CITY OF ALBUQUERQUE

INTER-OFFICE MEMORANDUM

TO: Dan Lewis, President, City Council
FROM: Alan Varela, Planning Director 
SUBJECT: **AC-24-24**, VA-2024-00233, PR-2022-006844,
BP-2024-10295, BP 2024-15349, BP-2024-15353

Martin Vigil appeals the Site Plan-Administrative decision to approve a Site Plan for all or a portion of TRACT A THE PEARL ADDITION (being a replat of Tracts 107-B, 107-C together with Tract 106-A within projected Section 18 T10 N, R3E) zoned MX-M and R1-A, located at 1701/1623 Central Avenue, NW containing approximately 0.5767 acre(s). (J-13)

Figure 2. The building location shown to be more than 50 feet from R1-A zoned lots.

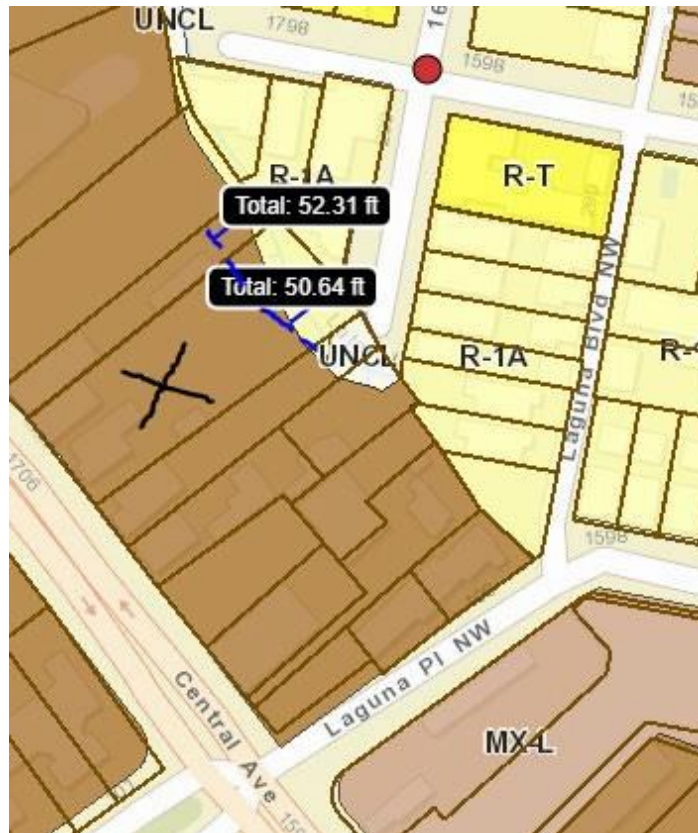
6. **Appellant:** Building height is limited to 30 feet in height in the Premium Transit Corridor. The proposed development is 48 feet high within 50 feet of existing single-family. The 4-story structure will be the tallest building on the block and does not conform to the pre-existing neighborhood or CPO-3.

Staff Response: The appellant is referring to IDO Section 14-16-5-9, a provision for Neighborhood Edge buffers. Protected lots must be zoned R-A, R-1, R-MC, or R-T and must contain low-density residential development. The proposed multi-family building is on the MX-M portion of the site making it a regulated lot. Central Avenue is both a Main Street and Premium Transit corridor, so the building could not be taller than 30 feet within 50 feet of a protected lot line. The proposed building is 48 feet tall, but the building is farther than 50 feet to any property zoned R-A, R-1, R-MC, or R-T. (See the map below.) The blue line shows a measurement 50 feet from the north property line; the black 'x' shows the general location of the 48-foot tall building. It is also noted that

the residential homes to the east and west are on parcels zoned MX-M and are not protected lots. Therefore, the 48-foot tall building is located on the lot where it is compliant with the IDO.
